**DESIGN CALCULATIONS
FOR
EVANS AND DRY CREEK
THROUGH
PARK 2001**

PREPARED FOR
THE RIBEIRO CORPORATION

MAY 13, 1987

Section 1 - Dry Creek

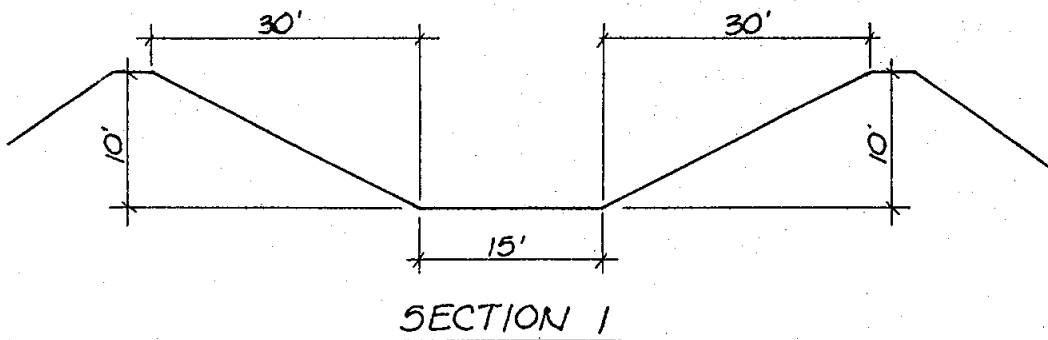
$$\begin{aligned}
 S &= 0.0005 \text{ FT/FT} \quad \leftarrow \text{.005} \\
 \checkmark N &= 0.025 \\
 A &= 400 \text{ SF} \quad 450 \\
 \checkmark WP &= 78.25 \text{ FT} \\
 R &= 5.11 \text{ FT} \quad \begin{matrix} 5.75 \\ 450 \end{matrix} \\
 Q &= \frac{1.49 (400) (5.11)^{2/3} (0.005)^{1/2}}{0.025} = 5001 \text{ CFS} \quad 6071
 \end{aligned}$$
